CITY COUNCIL REPORT

SUBJECT: ADDITIONAL INFORMATION REGARDING ITEM 112 ON THE JULY 1, 2016 FORMAL AGENDA – PUBLIC HEARING/ORDINANCE ADOPTION OF Z-81-15-8 LOCATED AT THE NORTHEAST CORNER OF 24TH STREET AND VINEYARD ROAD

This report provides additional information on Item 112 - Public Hearing/Ordinance Adoption of Z-81-1-8 located at the Northeast Corner of 24th Street and Vineyard Road for the July 1, 2016 Formal Agenda.

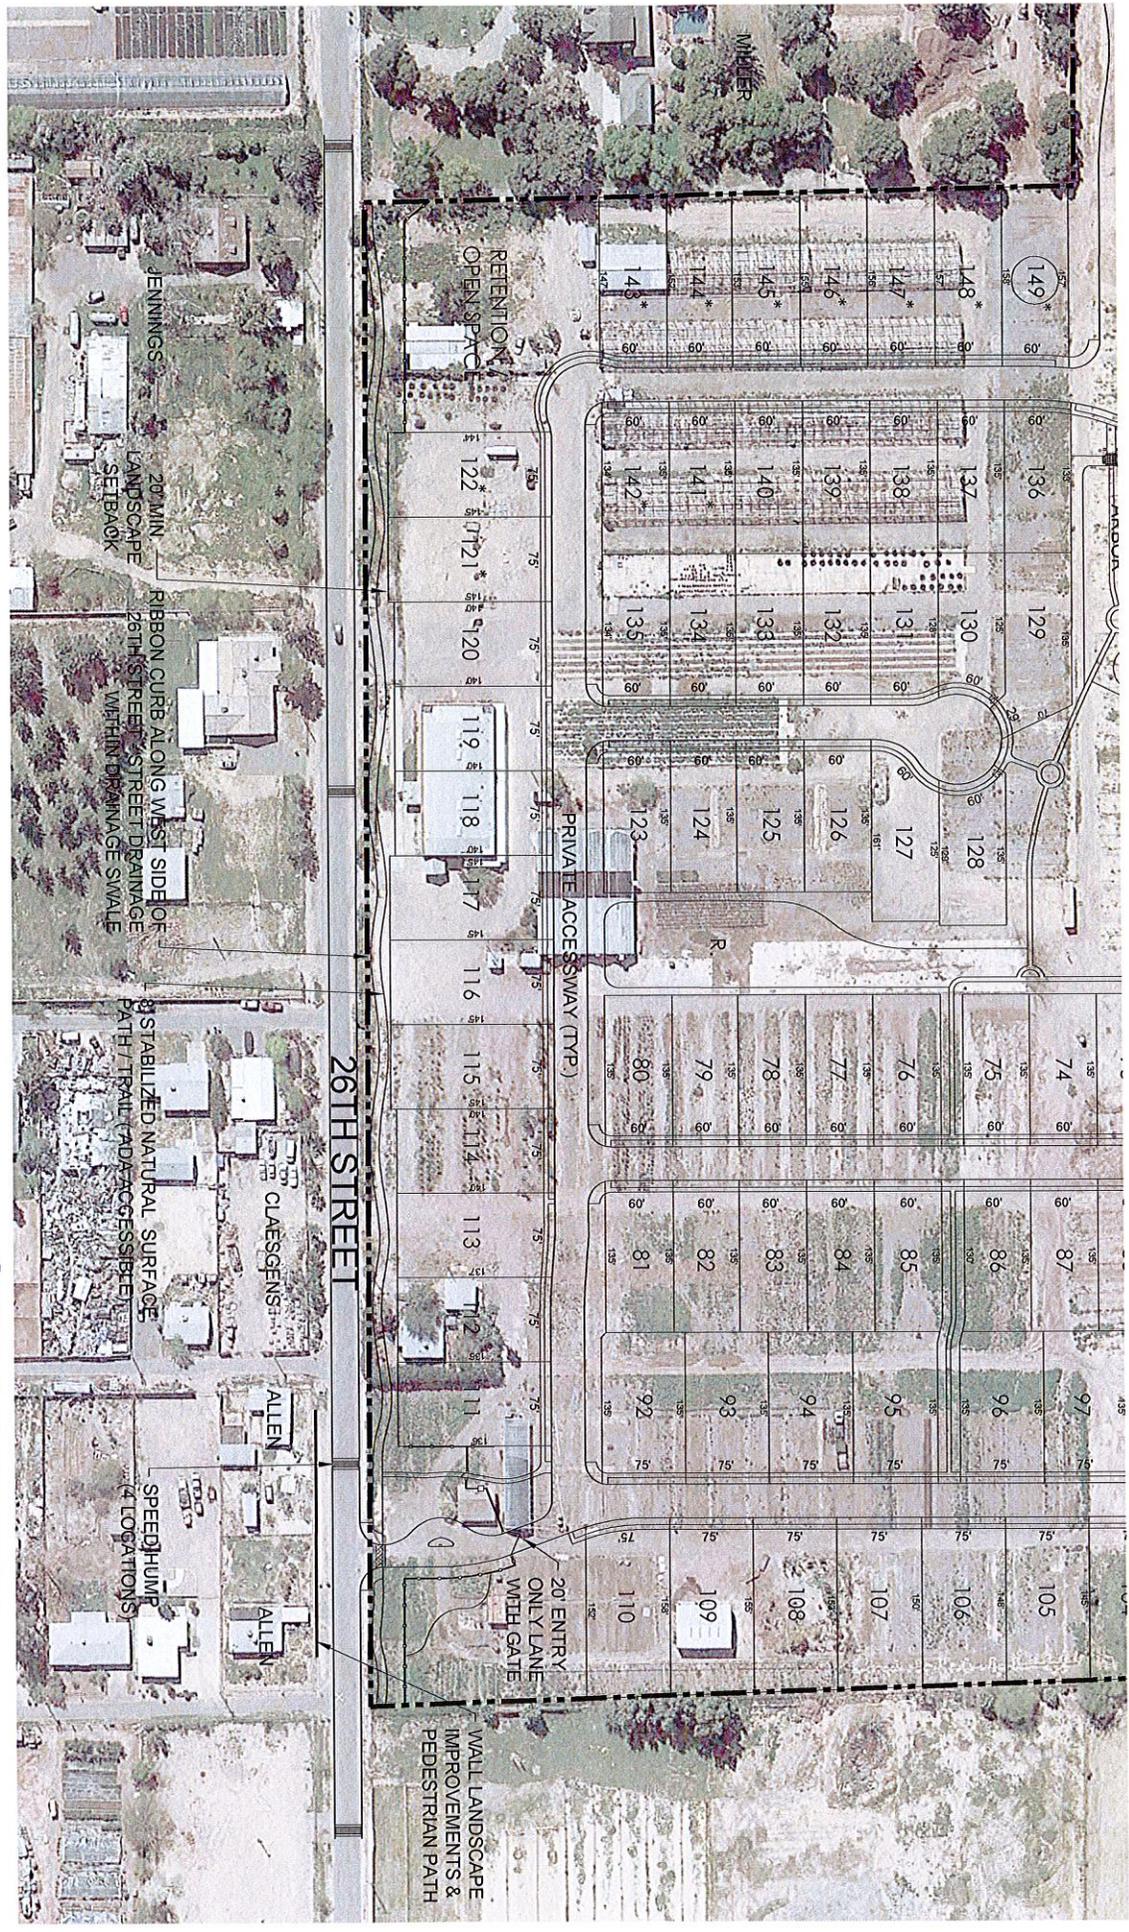
The applicant continued to work with adjacent residents and has made additional modifications to the request. These modifications are captured in the updated stipulations below and include the following:

- Updated site plan with new allotment of lot widths and enhanced landscaping
- New architectural design section for the Development Narrative
- Provision of a new driveway on 24th Street and restrictions on the driveway on 26th Street
- Deposit of funds for traffic mitigation on 26th Street
- Reduce density from 3.49 du/acre to 3.15 du/acre
- Provision of a trail along 26th Street in lieu of a sidewalk.

1.	THAT IN ADDITION TO THE STANDARDS IN THE DEVELOPMENT NARRATIVE, AS REVISED BY THE FOLLOWING STIPULATIONS, THE DEVELOPMENT SHALL BE IN GENERAL CONFORMANCE WITH THE PLANNED UNIT DEVELOPMENT SITE PLAN DATE STAMPED JUNE 29, 2016 WITH SPECIFIC REGARD TO THE FOLLOWING:

A.	LOTS 92 – 122 A MINIMUM OF 75 FEET IN WIDTH AND 135 FEET IN DEPTH
B.	LOTS 66-91 AND 123-149 A MINIMUM OF 60 FEET IN WIDTH AND 125 FEET IN DEPTH
C.	RIBBON CURB ALONG WEST SIDE OF 26TH STREET

D.	TRAFFIC DIVERTER AT PROJECT’S PRIMARY ENTRY ON VINEYARD ROAD
E.	PROVISION AND ARRANGEMENT OF TREES ON VINEYARD ROAD
F.	PROVISION AND ARRANGEMENT OF TREES ALONG THE ENTIRE LENGTH OF THE CENTRAL DRIVEWAY OFF OF VINEYARD ROAD AND CONTINUING ALONG PEDESTRIAN PATH INTO THE CENTRAL OPEN SPACE
